March 23, 2011
L-11-079

SUBJECT:
Davis-Besse Nuclear Power Station, Unit No. 1
Docket No. 50-346, License Number NPF-3
Reply to Request for Additional Information for the Review of the Davis-Besse Nuclear
Power Station, Unit No. 1, License Renewal Application (TAC No. ME4640)

March 23, 2011
L-11-089

SUBJECT:
Davis-Besse Nuclear Power Station, Unit No. 1
Docket No. 50-346, License Number NPF-3
Reply to Request for Additional Information for the Review of the Davis-Besse Nuclear
Power Station, Unit No. 1, License Renewal Application (TAC No. ME4640), Section 2.4

Davis-Besse Nuclear Power Station
Area Map, 50-Mile Radius
Page 1 of 1

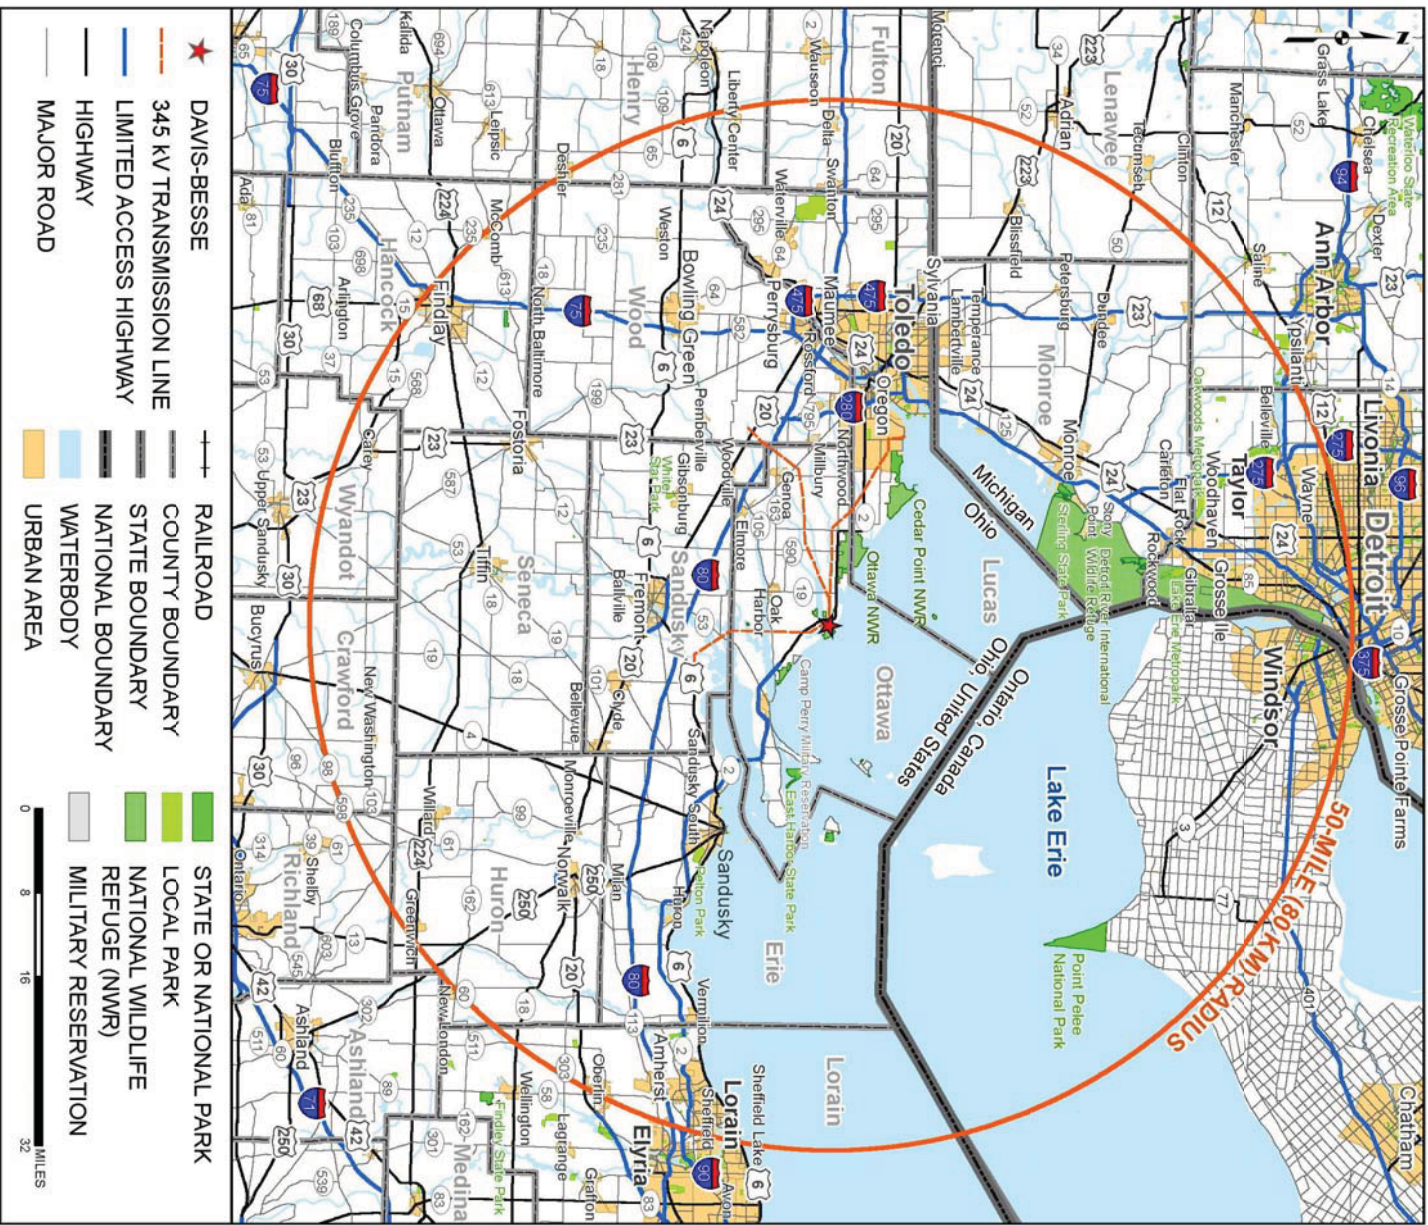
The transmission line corridors, however, extend further than the 6 miles shown on the map provided to the USFWS in the November 12, 2009, letter. As shown on Attachments 1 and 2 to this letter, the Bay Shore and Lemoyne transmission lines each extend 21 miles from the plant, and the Beaver transmission line extends 15 miles from the Davis-Besse plant.

Davis-Besse Nuclear Power Station
Transmission Line Map
Page 1 of 1

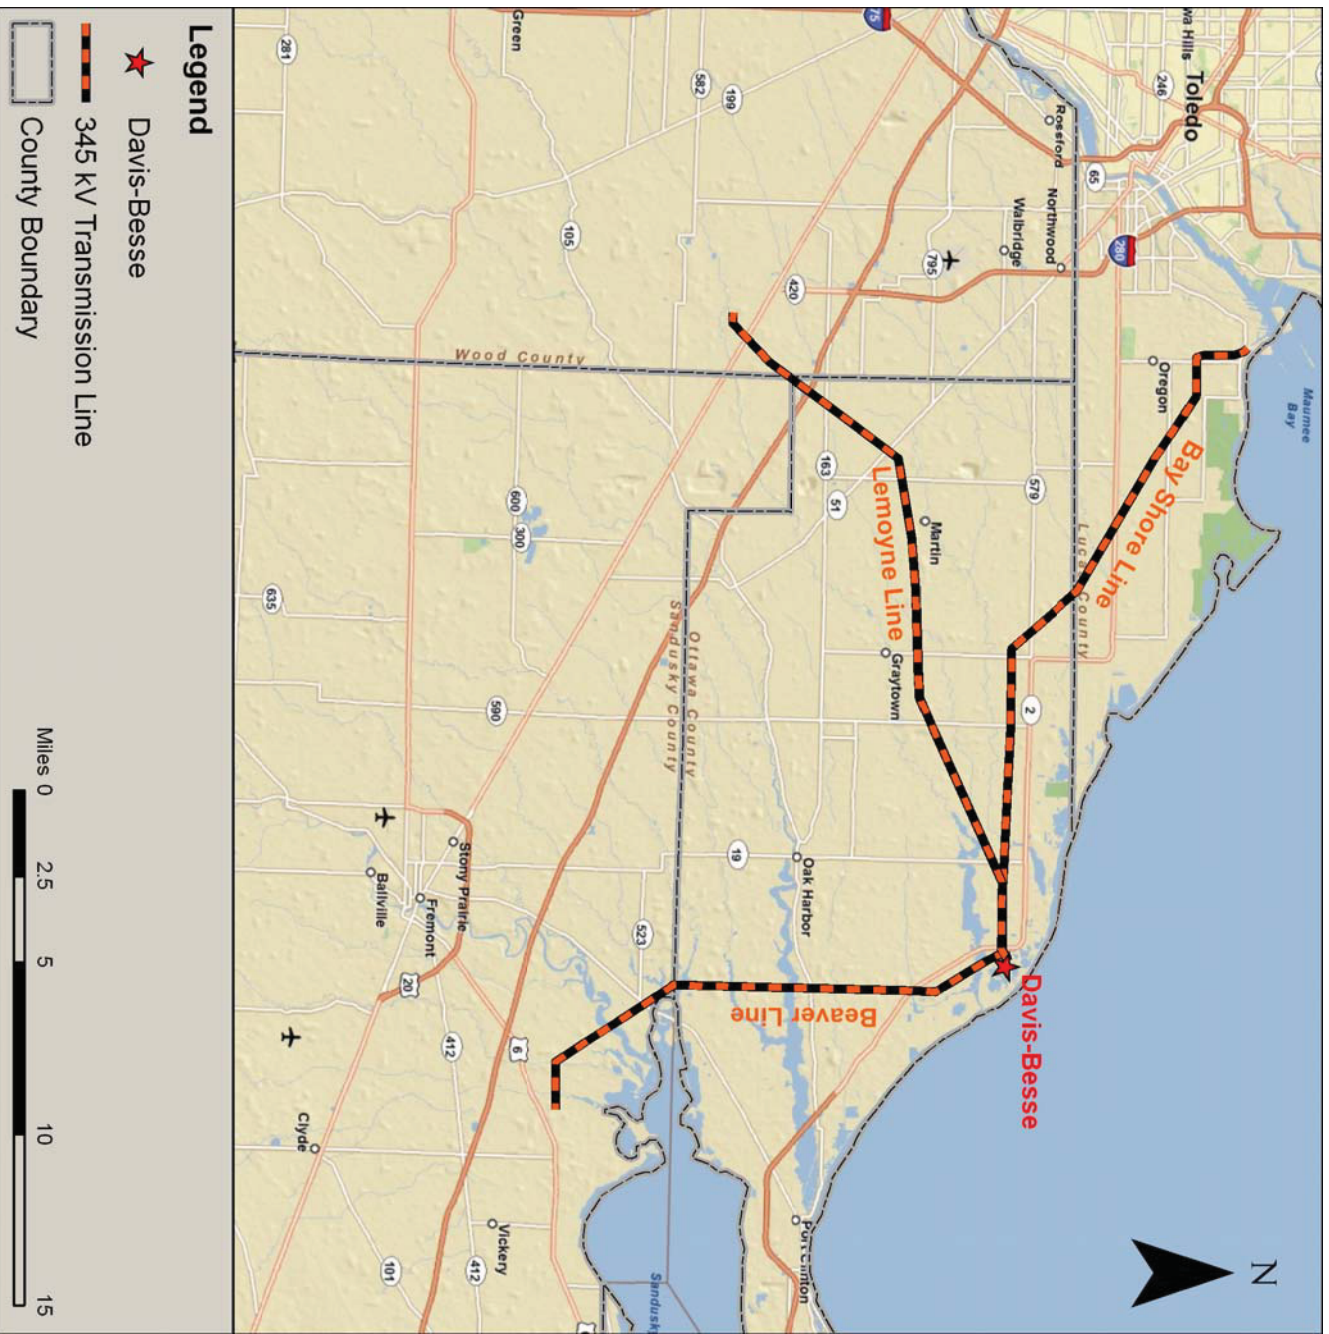
On November 12, 2009, First Energy Nuclear Operating Company (FENOC) contacted the U.S. Fish and Wildlife Service (USFWS) to request information regarding potential impacts the License Renewal Application (LRA) may have on Federally-listed species protected under the Endangered Species Act, including impacts from continued operation of Davis-Besse and the in-scope transmission lines and corridors. FENOC provided the USFWS with an area map showing the location of Davis-Besse and the three associated transmission line corridors out to a radius of approximately 6 miles from the plant. However, the Baysshore and Lemoyne transmission lines each extend 21 miles beyond the plant, and the Beaver transmission line extends 59 miles from the Davis-Besse plant. Please verify that USFWS has been provided maps inclusive of the entire project scope (including in-scope transmission lines) and that their findings and recommendations are still valid.

By letter dated March 21, 2011, FirstEnergy Nuclear Operating Company (FENOC) provided the U.S. Fish and Wildlife Service (USFWS) additional maps showing the entire Davis-Besse Nuclear Power Station, Unit No. 1 (DBNPS), license renewal project scope, including in-scope transmission lines. FENOC requested that the USFWS perform a review of the additional transmission line scope for threatened and endangered species to confirm whether their findings and recommendations from their December 16, 2009, letter to FENOC are still valid. See the Enclosure to this letter for a copy of the FENOC letter to the USFWS.

Based on the information in the NRC request for additional information (RAI), the transmission line corridor lengths within the scope of license renewal require clarification. As described in the NRC RAI, the Bay Shore and Lemoyne transmission lines each extend 21 miles from the plant, and the Beaver transmission line extends 59 miles from the Davis-Besse plant. The portion of the Beaver transmission line within the

scope of license renewal, however, is that portion of the line constructed by the original owner, Toledo Edison, as part of the DBNPS construction project and evaluated by the NRC in the Final Environmental Statement – Construction, March 1973, Section 3.7 and Figure 3.10, “Davis-Besse Nuclear Power Station Transmission Lines.” The Beaver transmission line constructed by Toledo Edison for the DBNPS project extends 15 miles south and southeast from the Davis-Besse plant as described in the DBNPS License Renewal Application, Appendix E, Environmental Report, Section 3.1.4. The remaining 44 miles of the Beaver transmission line was built by a separate utility company, Ohio Edison, as a separate project, and were not evaluated in the Final Environmental Statement as part of the DBNPS project.
